Access Compliance Report Public Rights-of-Way (Curb Ramps)

Main Street: RAINBOW_DR		Cross Street: CHAPLET_PL		Location:	S
ADA ID: RPRK220103155738	Ramp Type: Type 4 - Parallel	Initial Pass/Fail: Fail	Overall Compliance: No	Severity Score:	16
Codes/Mitigation Info/Possible Solution			Field Measurements/Component Compliance

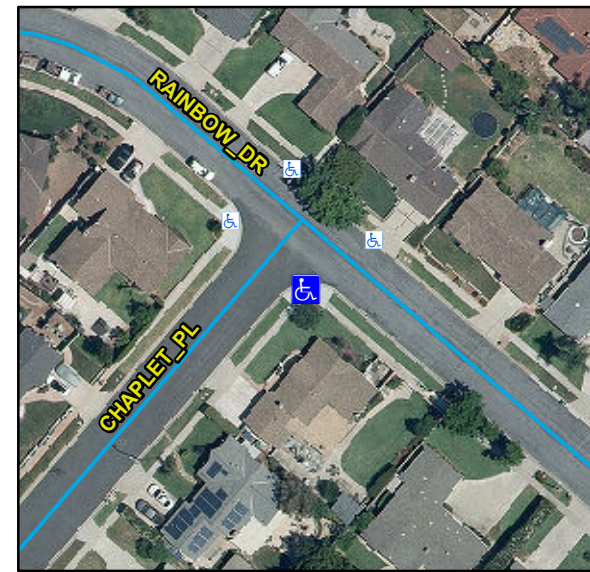
R304.3.2, R304.5.3, STD 1115

Remove & Replace Curb Ramp With Two New Directional Ramps or Equivalent.
